# Access Compliance Report

## Public Rights-of-Way

Intersection ID: 2983	Main Street: YELLOW_ROSE_LN	Cross Street: BROWNE_RD	Location: NW
ADA ID: 06B7459746D0	Ramp Type: Perp	Initial Pass/Fail: Fail	Overall Compliance: No
Severity Score: 22.5			
Codes/Mitigation Info/Possible Solution		Field Measurements/Component Compliance

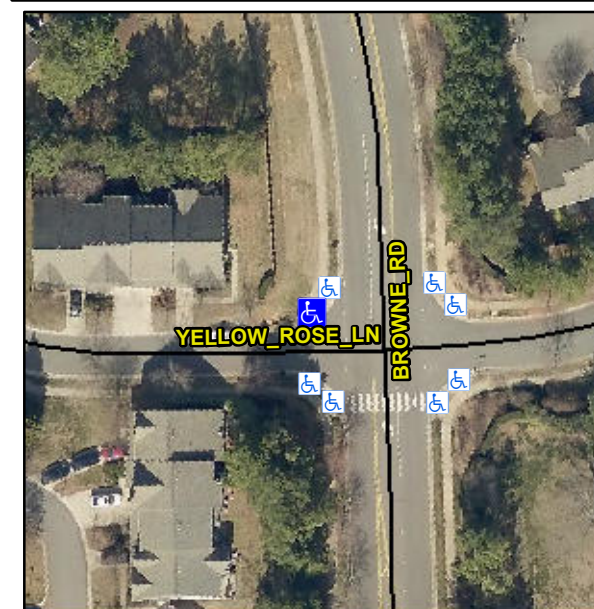
**R304.5.1, R304.2.2, R304.5.3**

Compliance	Description	Data	Compliance	Description	Data
N/A	Ramp Length (in)	57.0	No	Ramp Slope (%)	9.8
No	Ramp Width (in)	44.5	No	Ramp XSlope (%)	2.8
N/A	Flare Type LT	N/A	N/A	Flare Type RT	N/A
N/A	Flare Slope LT (%)	N/A	N/A	Flare Slope RT (%)	N/A
N/A	Flare Traversable LT?	N/A	N/A	Flare Traversable RT?	N/A
N/A	Landing Length (in)	N/A	N/A	DWS Provided?	N/A
N/A	Landing Width (in)	N/A	N/A	DWS Contrast?	N/A
N/A	Landing Slope (%)	N/A	N/A	DWS Length (in)	N/A
N/A	Landing X Slope (%)	N/A	N/A	DWS Full Width?	N/A
N/A	Landing Curb? (Y/N)	N/A	N/A	DWS Offset (in)	N/A
N/A	Shared Landing?	N/A			
N/A	Gutter Ponding?	N/A	N/A	Gutter Slope (%)	N/A
N/A	Gutter Lip Ht (in)	N/A	N/A	Gutter X Slope (%)	N/A
N/A	Painted X Walk1?	Yes	N/A	Painted X Walk2?	N/A
	X Walk 1 Direction	To S		X Walk 2 Direction	N/A
N/A	X Walk 1 Width (in)	120.0	N/A	X Walk 2 Width (in)	N/A
	X Walk 1 Slope (%)	1.5		X Walk 2 Slope (%)	N/A
	X Walk 1 X Slope (%)	0.0		X Walk 2 X Slope (%)	N/A

**Remove & Replace Entire Ramp.  
Restripe Crosswalk.**
